Subject: Response to the FCC Correspondence Reference # 21583 / 21584 for additional information on RIM BlackBerry Wireless Handheld FCC ID: L6AR6230GE, 731 Confirmation # TC493009

The following addresses the comment on your **Correspondence Reference # 21583 / 21584**, dated July 12, 2005.

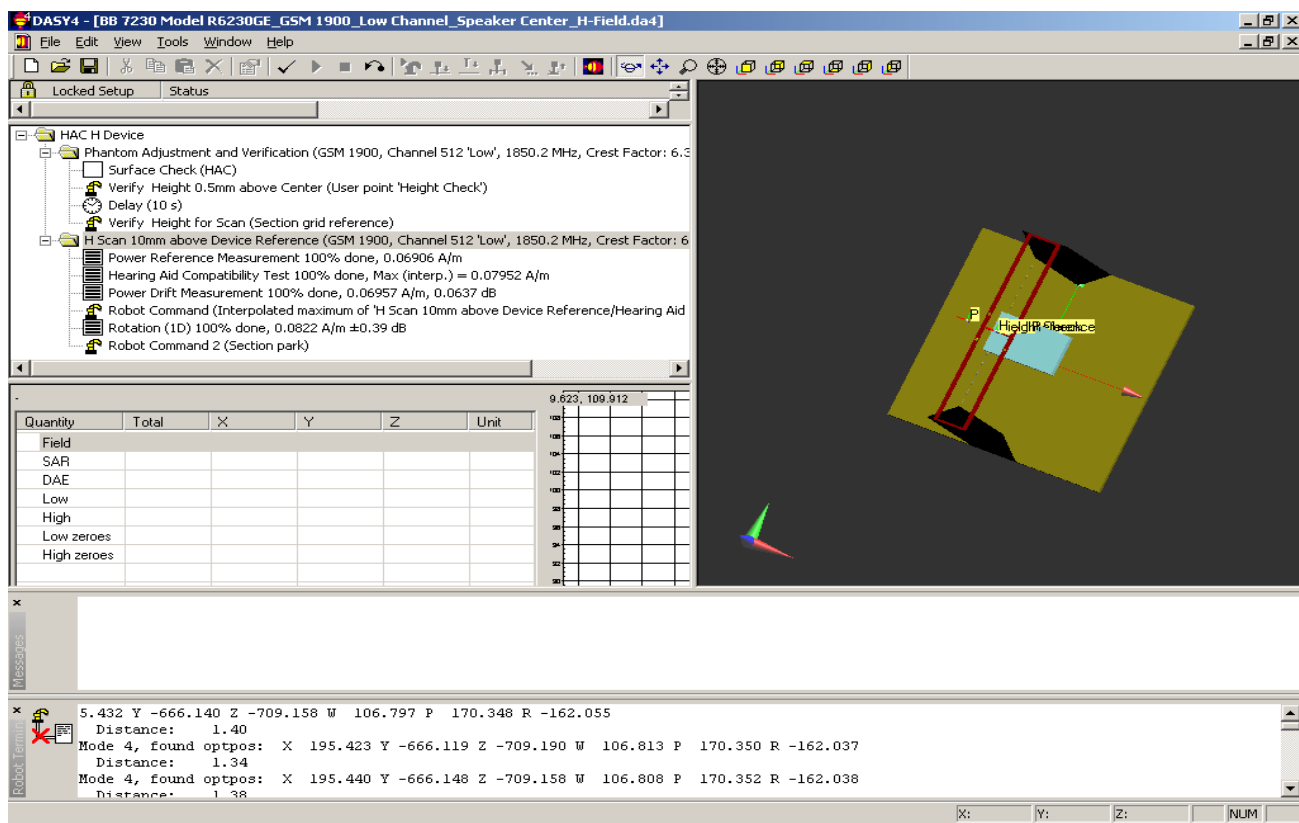
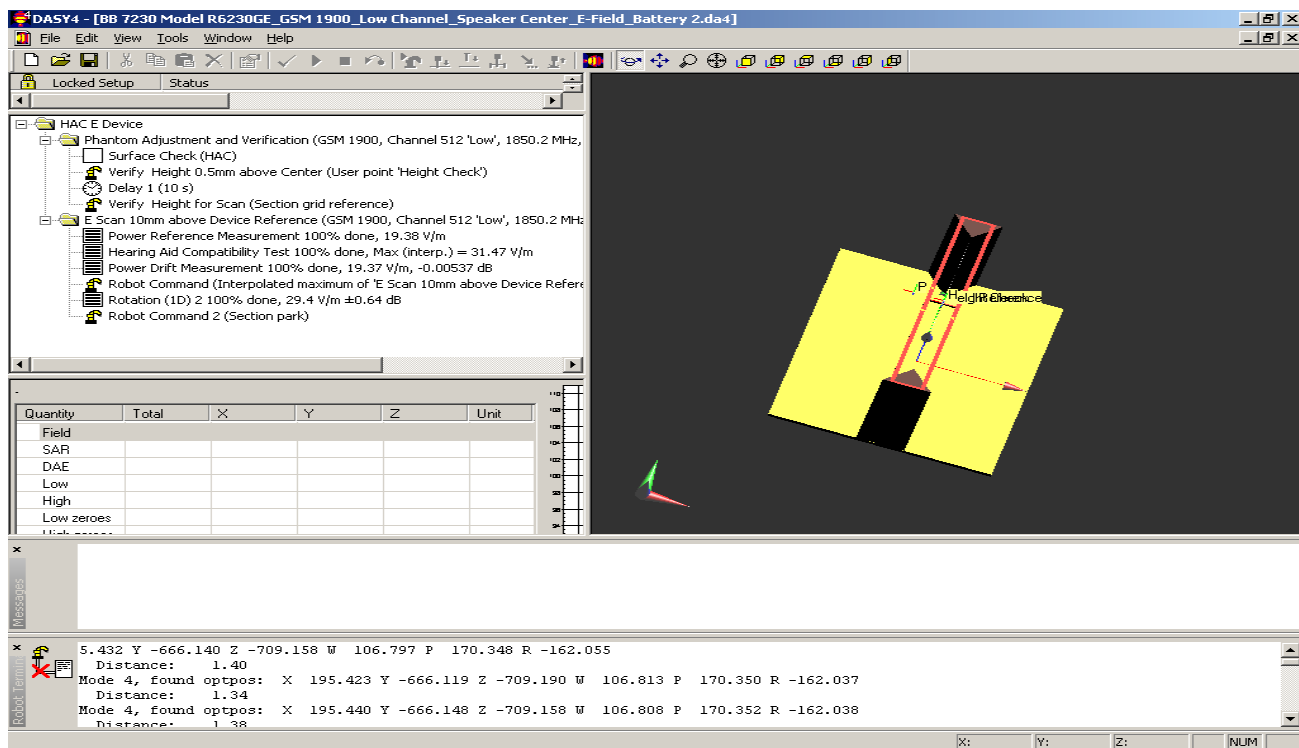
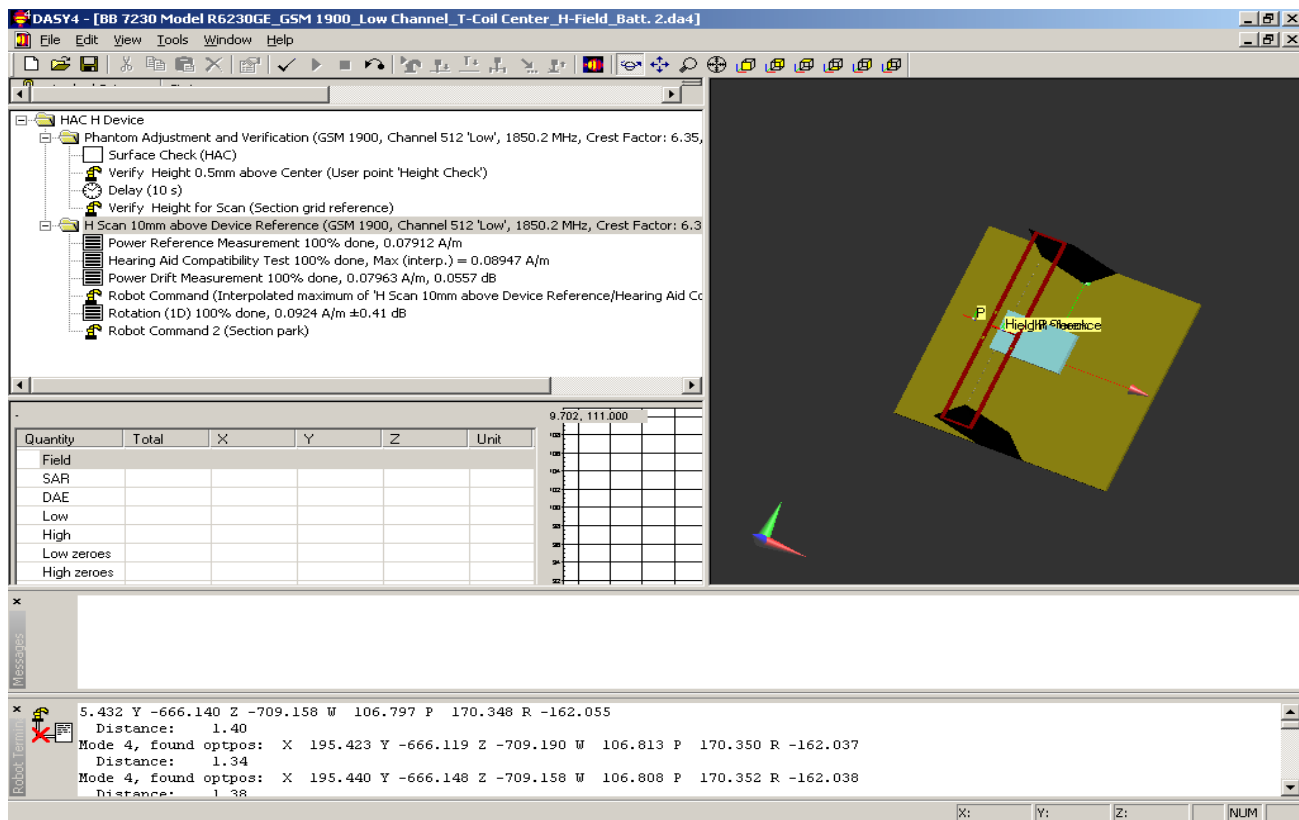
E) FYI Please note that Crest Factor and modulation factor are not always related by the squared relationship that you provide.

DASY4 software calculates the modulation factor as  $PMF = \sqrt{CF}$  where CF is entered by the user and is the square of the calculated modulation factor.

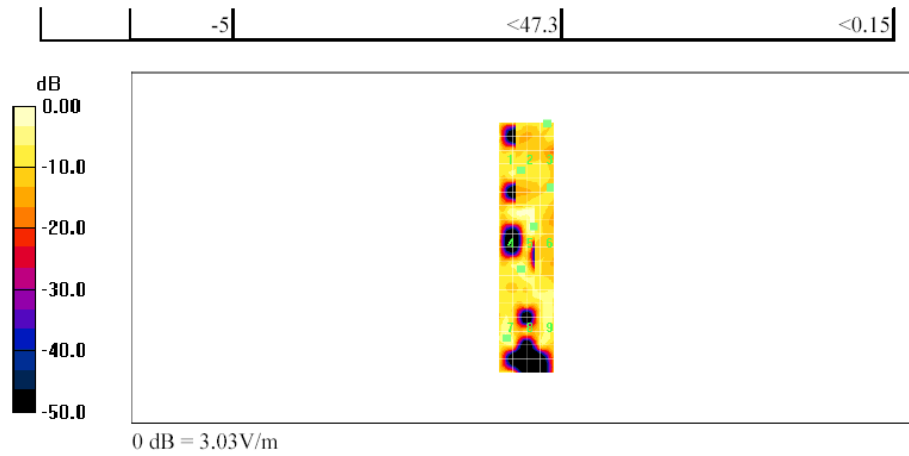
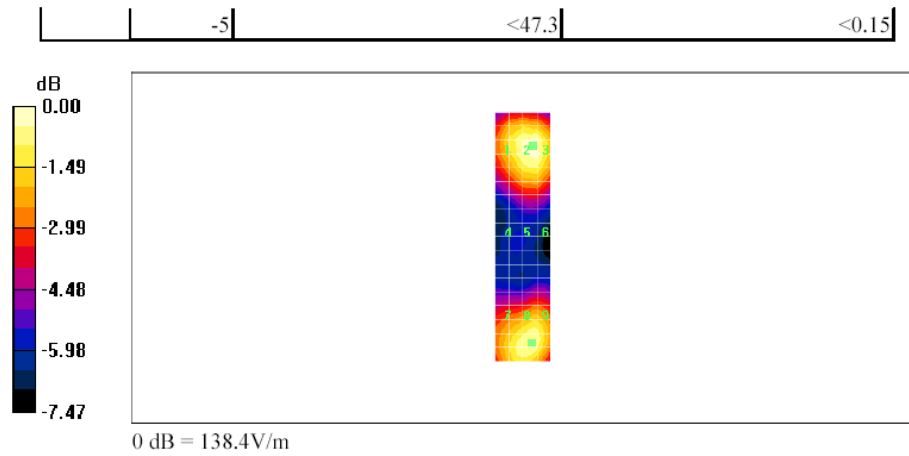
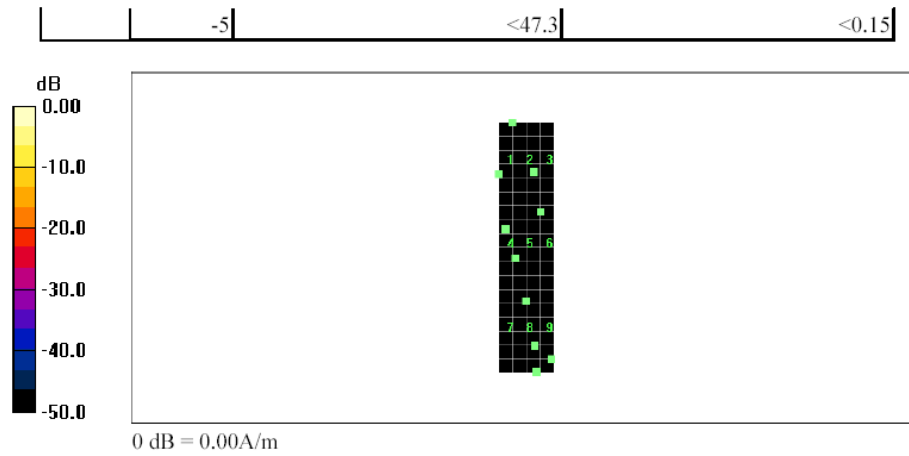
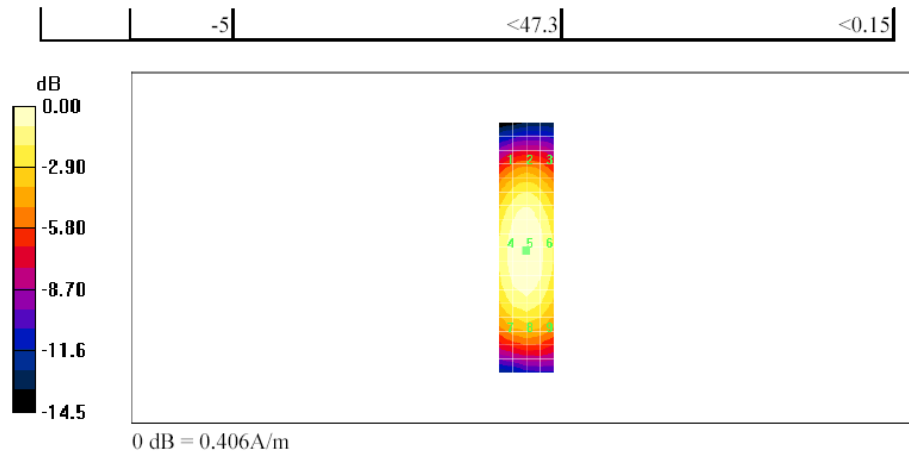
**K) A discussion of the site-specific uncertainty components could not be located.**

C63.19 requires ambient noise to be at least 20dB below the measurement level. Please see below for E- and H-Field ambient noise measurements and dipole validation plots. The ambient E-Field level was determined to be 3.03 V/m and the ambient H-field level 0.001 A/m. The ambient noise was determined to more than ~ 32 dB below the dipole validation results with an input power of 20 dBm.

**Figure 1: E-Field Probe (ER3DV6)**

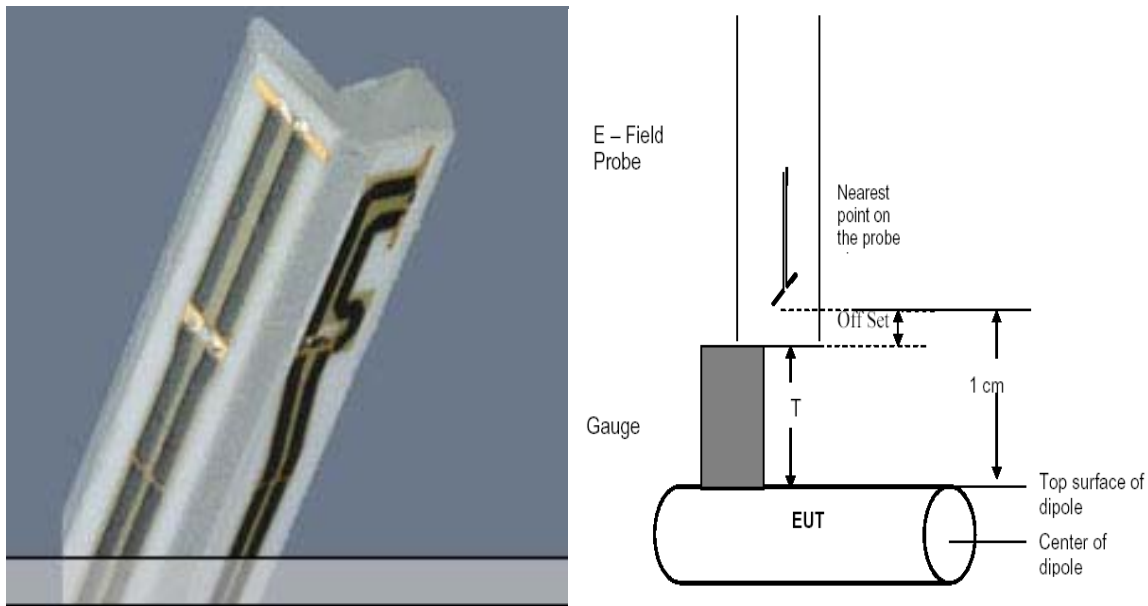
**IV The Speag Dasy 4 typically measures to the center of the sensor. C63.19 recommends device measurement to the nearest element point. Please justify. Please include additional illustrations of the probe/elements showing more detail of the probe tip area.**

All measurements were performed to the nearest element point as per the C63.19 standard. Offset distances were entered in the DASY4 software so that the measurement was to the nearest element.

Figures 1 and 2, provided by the manufacturer, illustrate detail of the probe tip and its dimensions.

**ER3DV6** E-Field probe: The distances from the probe tip to the closest points on the dipole sensors are 1.45mm for X and Y and 1.25mm for Z. From the probe tip to the center of the sensors is 2.5mm.

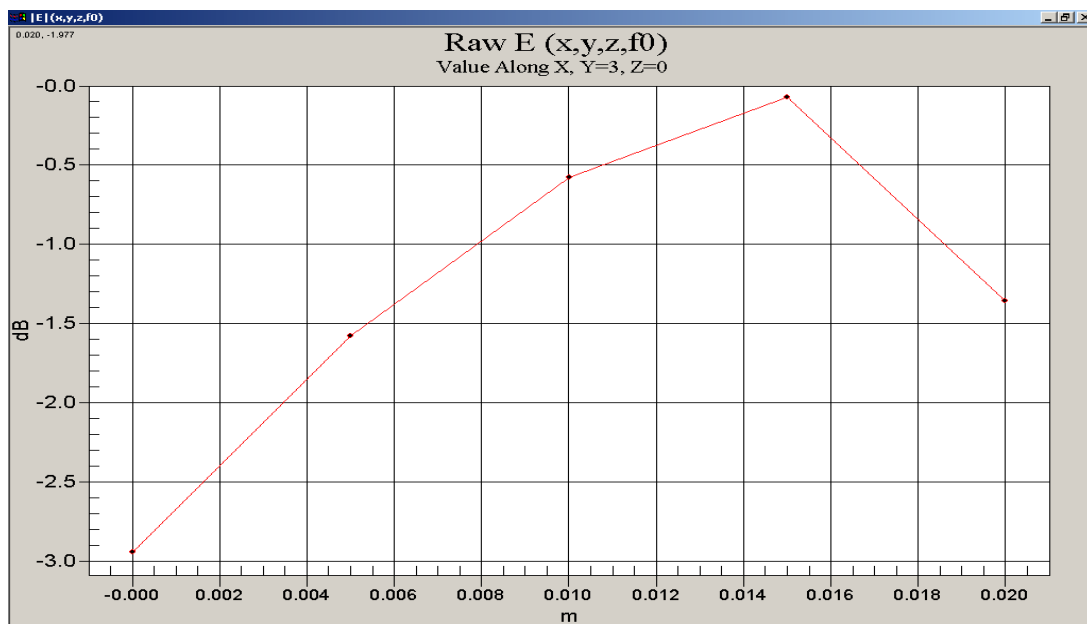
**V Please provide additional details of the WD's signal. How was the signal set up and controlled? What was the source for the validation test?**

A Rohde & Schwarz CMU 200 base station simulator was used to establish a radiated connection with the WD. The base station simulator's Power Control Level was set to 0 to force WD to transmit at maximum power of ~ 30 dBm. Other parameters are: Channel type = full rate, Discontinuous transmission off.

For validation and modulation factor measurement, an Agilent signal generator, model E4433B was used to generate CW, AM and GSM modulated signals.

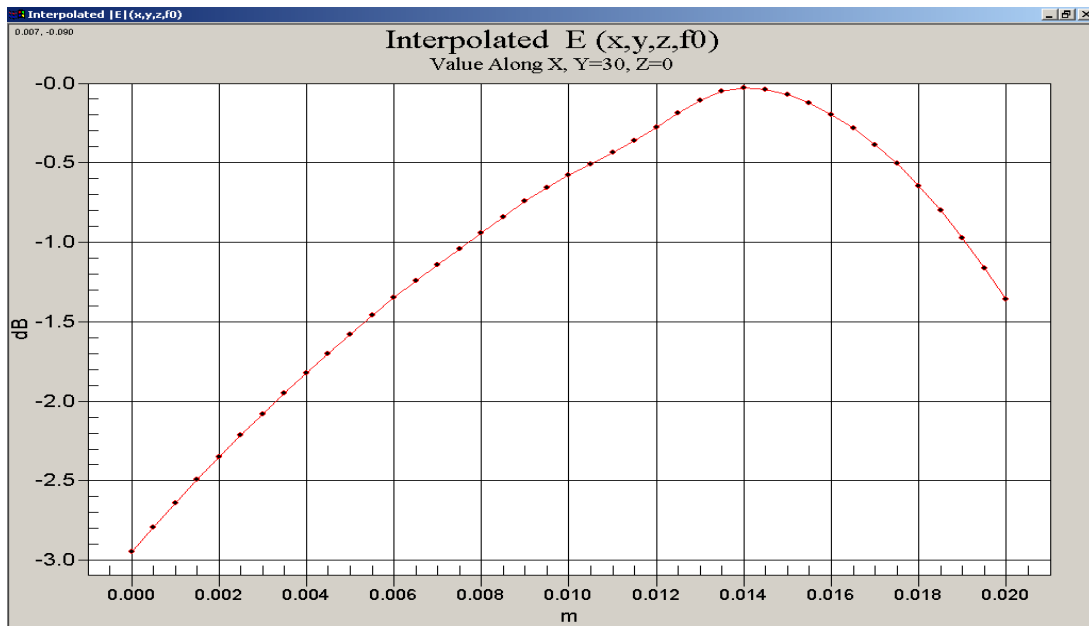
**VII Please demonstrate that 5 mm step size is sufficient for both verification and WD measurement. One means might be though use of a two dimensional plot of field strength versus distance in a direction perpendicular to the length of the dipole. Was any interpolation used?**

Please see the 2-D plots of raw and interpolated field strength versus distance in a direction perpendicular to the length of the dipole. The DASY 4 uses interpolation algorithms to derive 9 interpolated points between every measured point.

This figure shows the raw measured field strength perpendicular to the dipole. The TCB guidance slides require the 3dB width to be much larger than the step size. The width from the 0 to -3dB points is > 21mm, 4 times the step size.

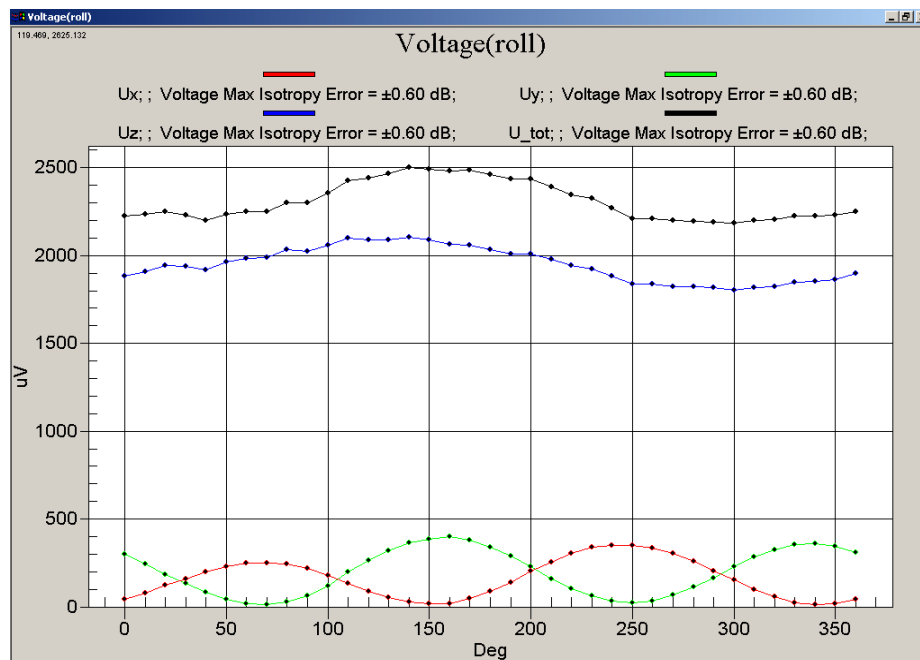
**VIII To help clarify dynamic range issues, if possible, please state the highest measured voltage at the diode compared to its compression point.**

The diode compression point in the calibration certificate is stated to be ~95 mV for E-field as shown below.

The maximum measured voltage at each diode for the worst-case scan is determined to be ~ 2.5 mV which is much lower than the compression point.
